# Access Compliance Report

## Public Rights-of-Way

Intersection ID: 47570	Main Street: HERMSLEY_RD	Cross Street: GAILES_DR	Location: SE
ADA ID: BFA62E08EC7F	Ramp Type: PerpDiag	Initial Pass/Fail: Fail	Overall Compliance: No
Severity Score: 21.25			
Codes/Mitigation Info/Possible Solution		Field Measurements/Component Compliance

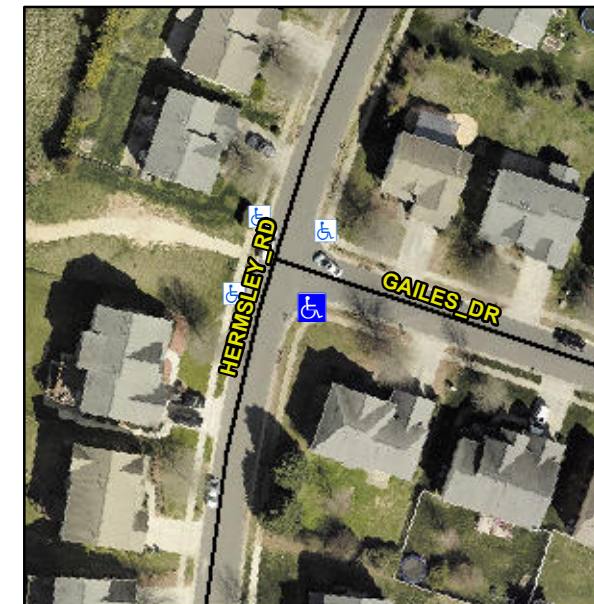
**Remove & Replace Curb Ramp With Two New Directional Ramps or Equivalent.**

**R304.5.1, R304.2.2**

Compliance	Description	Data	Compliance	Description	Data
N/A	Ramp Length (in)	46.0	No	Ramp Slope (%)	9.8
No	Ramp Width (in)	46.0	Yes	Ramp XSlope (%)	0.3
N/A	Flare Type LT	N/A	N/A	Flare Type RT	N/A
N/A	Flare Slope LT (%)	N/A	N/A	Flare Slope RT (%)	N/A
N/A	Flare Traversable LT?	N/A	N/A	Flare Traversable RT?	N/A
N/A	Landing Length (in)	N/A	N/A	DWS Provided?	N/A
N/A	Landing Width (in)	N/A	N/A	DWS Contrast?	N/A
N/A	Landing Slope (%)	N/A	N/A	DWS Length (in)	N/A
N/A	Landing X Slope (%)	N/A	N/A	DWS Full Width?	N/A
N/A	Landing Curb? (Y/N)	N/A	N/A	DWS Offset (in)	N/A
N/A	Shared Landing?	N/A			
N/A	Gutter Ponding?	N/A	N/A	Gutter Slope (%)	N/A
N/A	Gutter Lip Ht (in)	N/A	N/A	Gutter X Slope (%)	N/A
N/A	Painted X Walk1?	No	N/A	Painted X Walk2?	No
	X Walk 1 Direction	To NE		X Walk 2 Direction	To NW
N/A	X Walk 1 Width (in)	N/A	N/A	X Walk 2 Width (in)	N/A
	X Walk 1 Slope (%)	1.0		X Walk 2 Slope (%)	1.6
	X Walk 1 X Slope (%)	2.6		X Walk 2 X Slope (%)	1.4
